**CERTIFICATE OF APPROPRIATENESS**

**Property:** 7542 Cayton Street, Lot 12, Block 44, Glenbrook Valley Neighborhood Subdivision. The property includes a historic 1,712 square foot, one-story brick single-family residence and an attached garage situated on an 8,050 square foot interior lot.

**Proposal:** Alteration – replace roofing system

ROOF PLAN PROPOSAL:

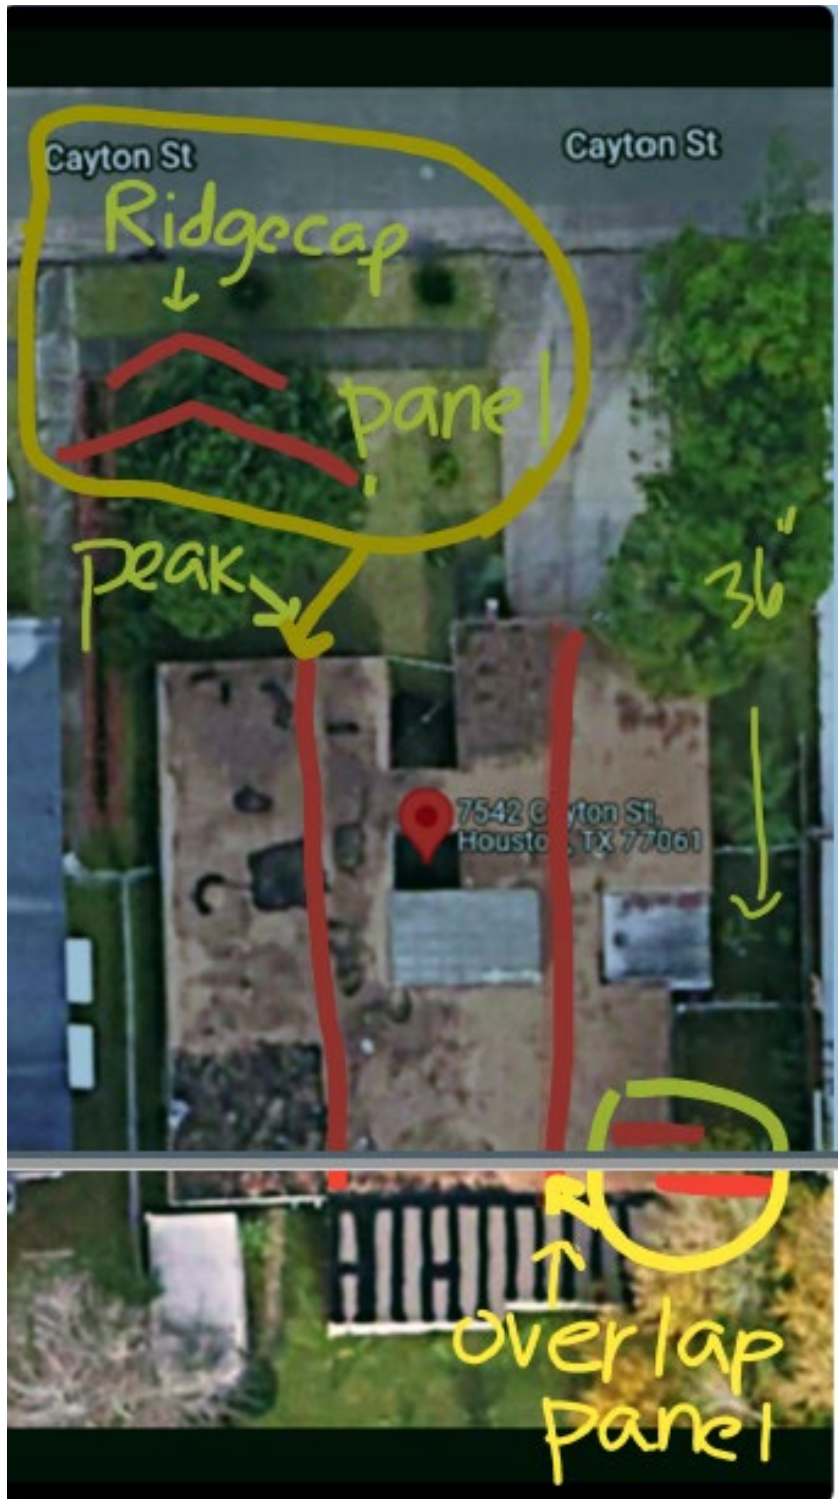
- Owner to replace existing roof and temporary cover with steel substrate roof to fit within perimeter of existing roofline and will be minimally visible from the street due to the low pitch. Areas of the interior courtyard were covered by a temporary synthetic material previously (see aerial view) and due to inadequate drainage have caused water damage on front entry. Proposal includes the cover of those areas to protect the structure. Full ridge cap and overlapped panels will be supported by a membrane to help with appropriate water drainage and gutter system to be installed in future (exempt from COA). See owner email on page 19 for construction details.

ROOF WILL BE INLINED INTO EXISTING ROOF EDGE

AND DUE TO LOW PITCH, WILL BE MINIMALLY VISIBLE FROM THE STREET.

**PROPOSED MATERIAL:**

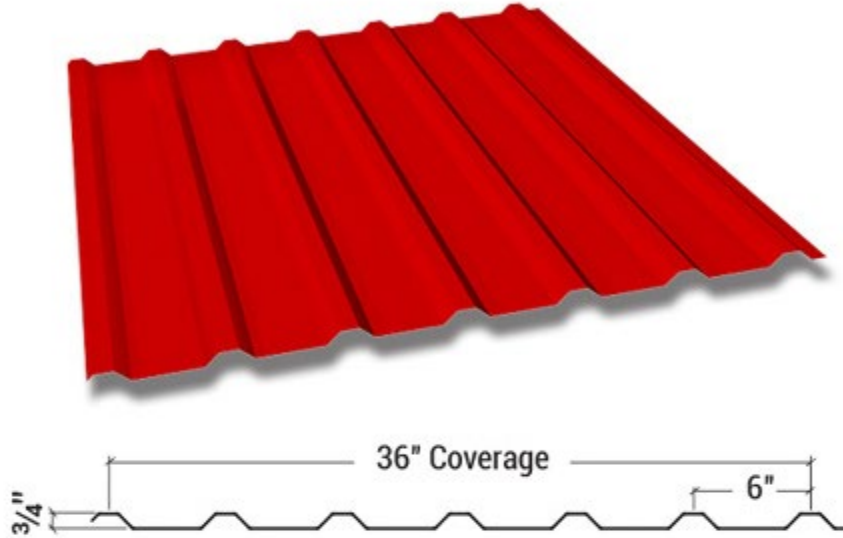
| <input checked="" type="checkbox"/> | <input type="checkbox"/> | <input type="checkbox"/>            | (6) New materials to be used for any exterior feature excluding what is visible from public alleys must be visually compatible with, but not necessarily the same as, the materials being replaced in form, design, texture, dimension and scale;<br><i>New materials are visually compatible with existing form and will prevent future damage to the building.</i>  |
| <input checked="" type="checkbox"/> | <input type="checkbox"/> | <input type="checkbox"/>            | (10) The proposed alteration or addition must be compatible with the massing, size, scale material and character of the property and the context area; and<br><i>While there are few metal roofs in this area, the slope of this particular roof and proposed material will not detract from the context area and should be considered compatible.</i>  |
